**Application by Rosefield Energy Farm Limited for an order
granting development consent for the Rosefield Solar Farm**

(EN010158)

CLOSING STATEMENT

Claydons Solar Action Group (CSAG)

Fig 1) Map showing proposed and recently permitted development in Claydons area

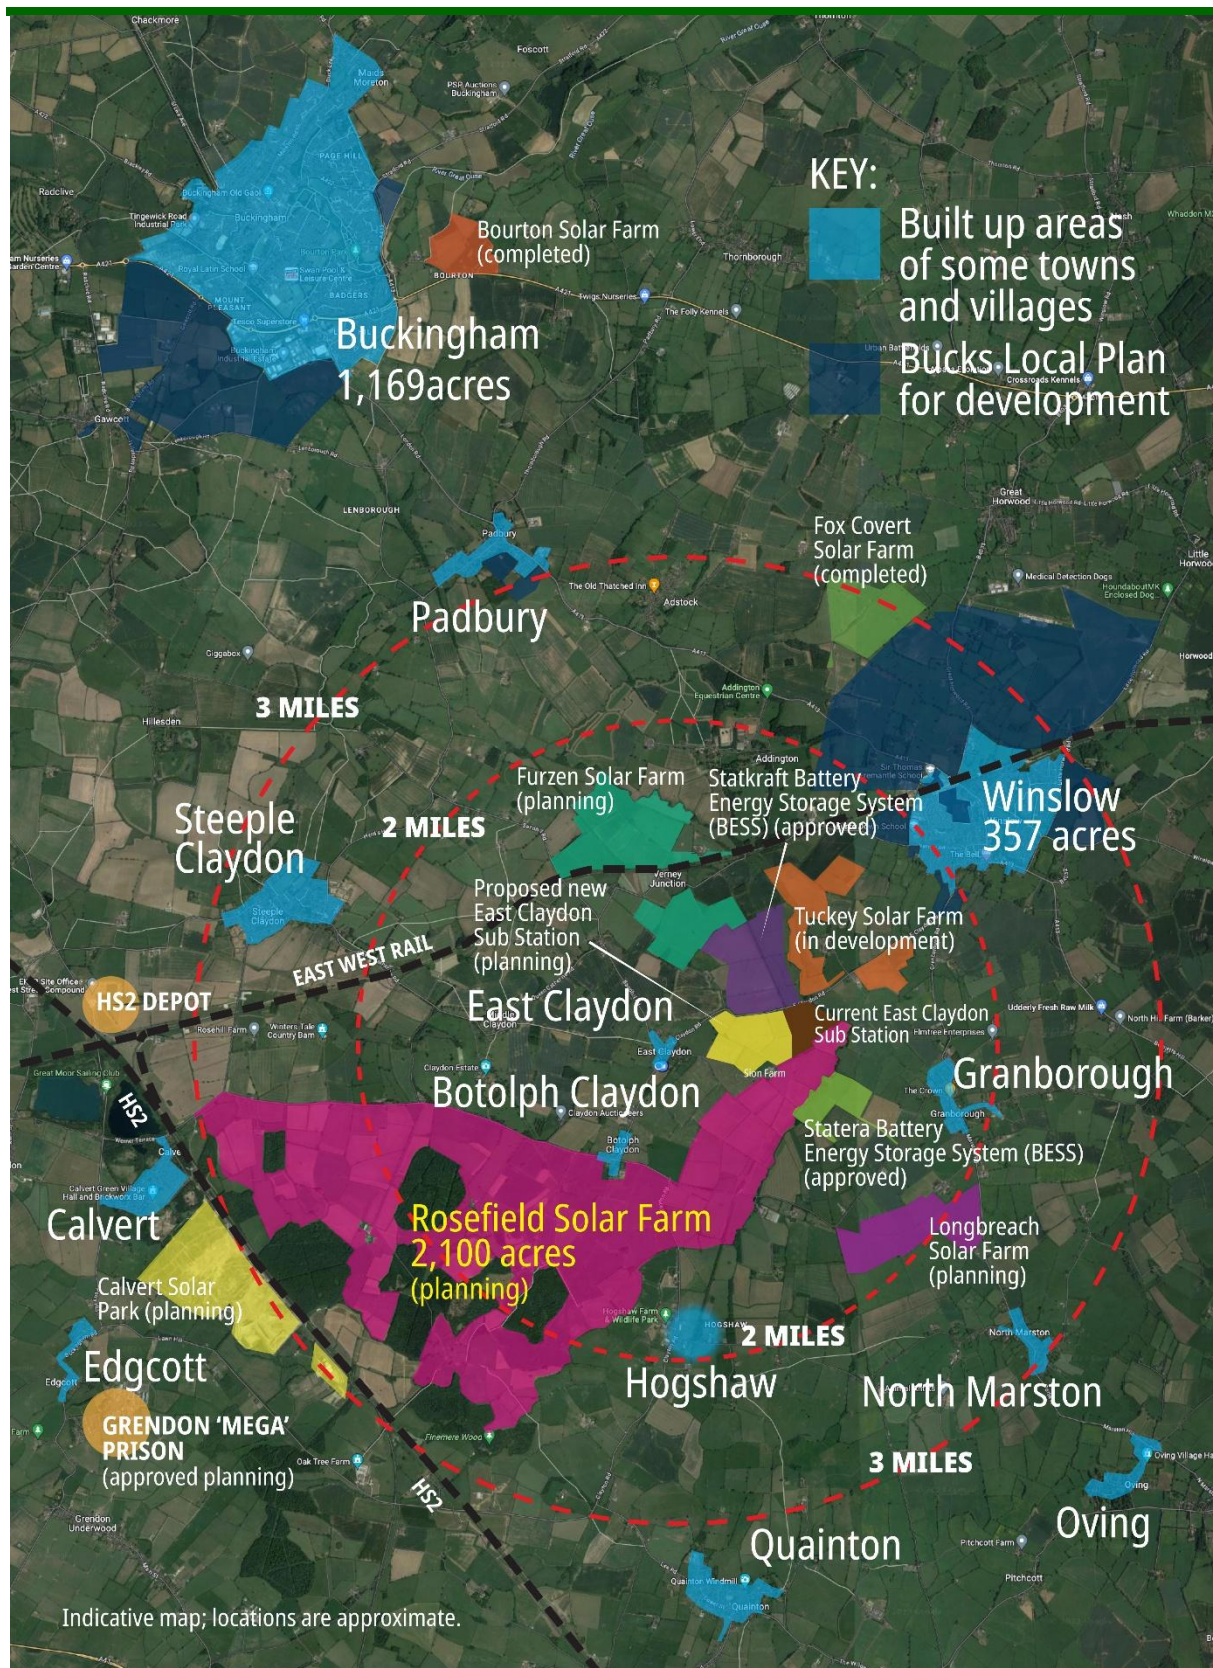
3. The proposals would occupy an important oasis of open land remaining between these developed and developing areas (see Fig. 1 above), land highly valued for its biodiversity, heritage and recreational value, including public rights of way affording long distance views over the open countryside.

Fig. 1. Extract From DEFRA's Magic Map showing 10 km radius of East Claydon Sub-Station, showing protected sites, ancient woodland, listed buildings and scheduled monuments.

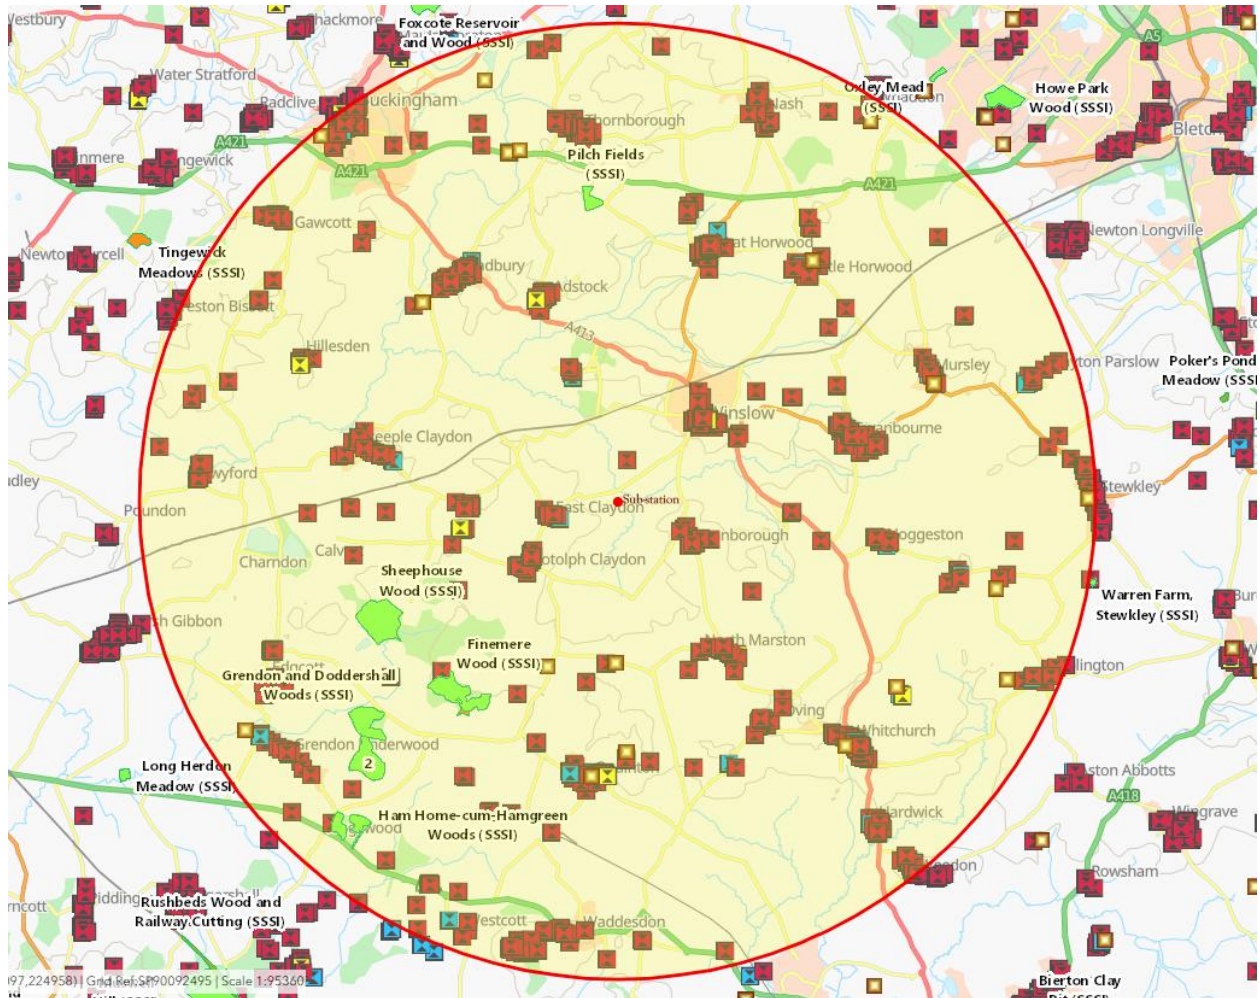
20. As Fig. 2. below shows, the land within the Order Limits is subject to greater environmental constraints than any other area within the Applicant's chosen 10km site search radius.
